April 19, 2023

I am submitting these brief comments on the December 20, 2022 Permit Renewal draft Permit (**draft Permit**) issued by the New Mexico Environment Department (**NMED**) for the Waste Isolation Pilot Plant (**WIPP**). The draft Permit is based upon a Renewal Application submitted to NMED by the US Department of Energy (**DOE**) Carlsbad Field Office and Nuclear Waste Partnership (**Permittees**) on March 31, 2020, along with an Updated redline strikeout (**RLSO**) for the Renewal Application on March 17, 2022. The draft Permit also includes changes proposed by NMED to address their concerns.

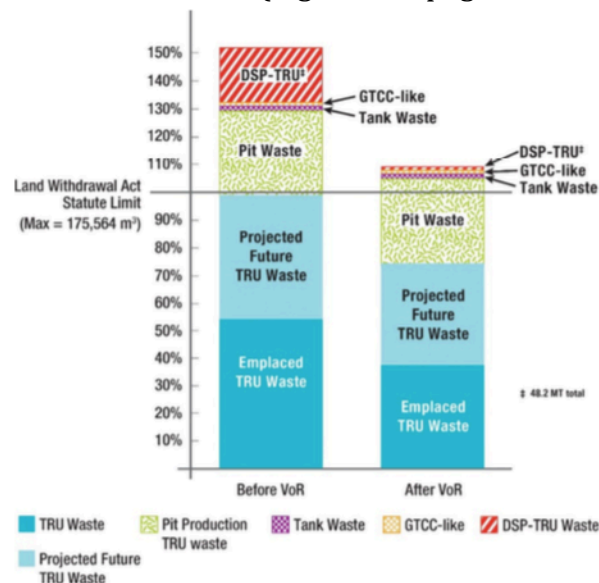
Although not available at that time, a later April 2020 final report issued by the National Academy of Sciences entitled, “Review of the Department of Energy's Plans for Disposal of Surplus Plutonium in the Waste Isolation Pilot Plant” ([AR 200505](#)) addressed many concerns about disposal of surplus plutonium and other proposed waste streams at WIPP. Because the VoR had already been implemented in the WIPP Permit, the NAS report presented a graph of the volumes of emplaced and future TRU waste stream estimates before and after implementation of the VoR (Figure 3-9, page 67, PDF page 80).

As is obvious from this graph, VOR is absolutely necessary in order for WIPP to accept any waste beyond the projected future TRU waste that DOE has already anticipated in their Annual TRU Waste Inventory Reports (**ATWIR**). Stated another way, VOR is unnecessary if other historically unanticipated wastes are excluded from disposal at WIPP. These arguments were not allowed to be considered during the 2018 VOR hearing.

Figure 1 - Number of 12" POC Containers Disposed by Year

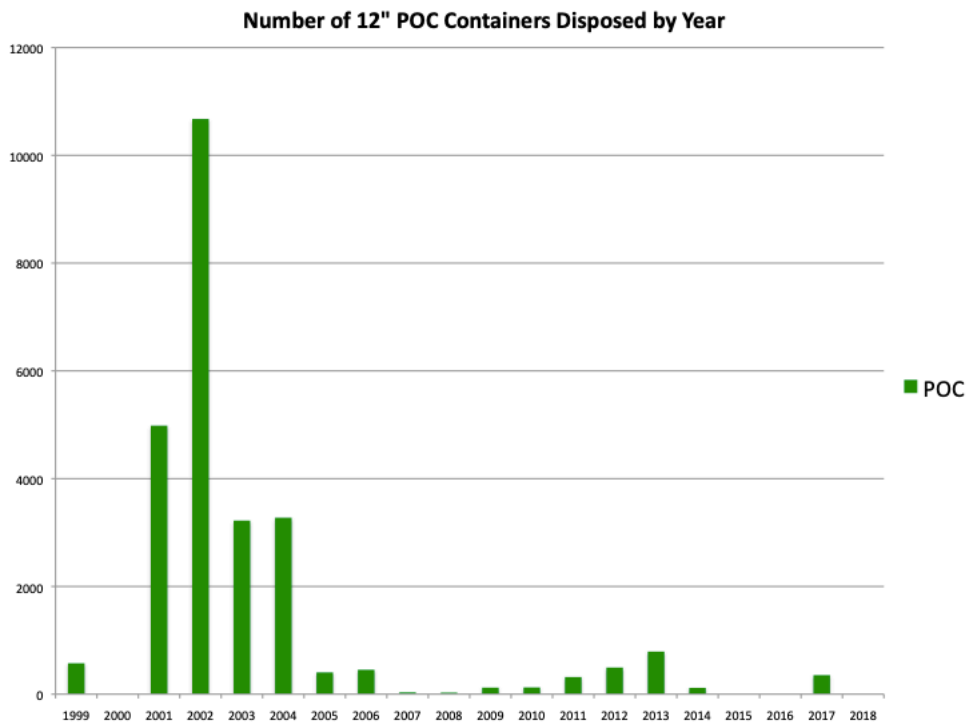
Unfortunately, I didn't include spreadsheet and graphs depicting the disposal of these containers over time. When I attempted to introduce this information during my direct testimony at the hearing, it was denied because I hadn't included it with my pre-filed testimony ([AR 181033](#), Day 3, p. 66-71, PDF p. 591-596). However, I've attached the spreadsheet to my comments and include the graphs here, reflecting emplacements through September 12, 2018.

Rocky Flats shipped 21,174 POC containers for emplacement between June 1999 and April 2005, representing 92% of POCs emplaced during that time. The Permittees clearly were aware of this significant number of POC containers emplaced in Panels 1 and 2.

Figure 2 – Number of Other Overpack Containers Disposed by Year

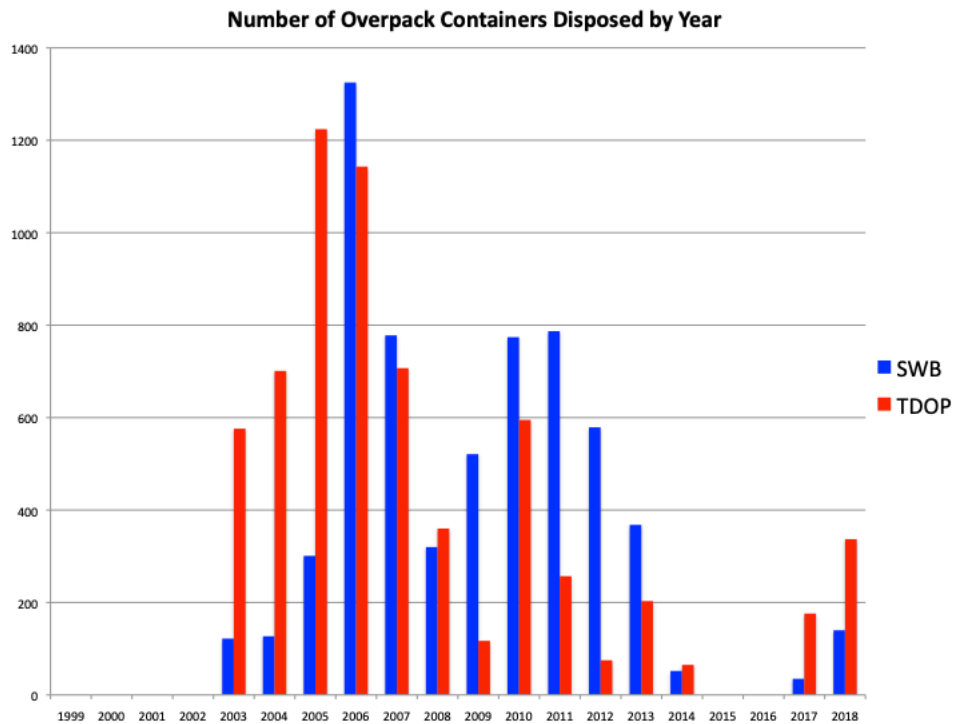
The Permittees received the first shipments of both SWB overpacks and TDOPs in 2003, with the greatest annual emplacement of TDOPs occurring in the 2005-2006 timeframe. Very few TDOPs are direct loaded (not shown here, but only 26 between 2013 and 2017), and nearly all TDOPs are overpacking up to ten 55-gallons drums. The majority of these are for purposes of “payload management,” which may have been “unanticipated” when the Permittees first submitted their application for a disposal permit back in 1995, but it was a conscious decision by DOE to develop and implement it. As I had pointed out in my written testimony at the VOR hearing, using TDOPs for payload management is generally a “bad” packaging decision from efficiently using WIPP disposal capacity because it allows low activity containers that don’t meet the TRU alpha activity concentration requirement on their own to qualify for disposal by averaging the TRU alpha activity concentration across multiple high activity containers. In any case, these two figures show that the impact of overpacking over time is clearly discernable and that the statement that “... the DOE did not anticipate... the need to overpack numerous containers prior to shipping” is unsupported. ([AR 180706](#), p. 6, PDF p. 9)
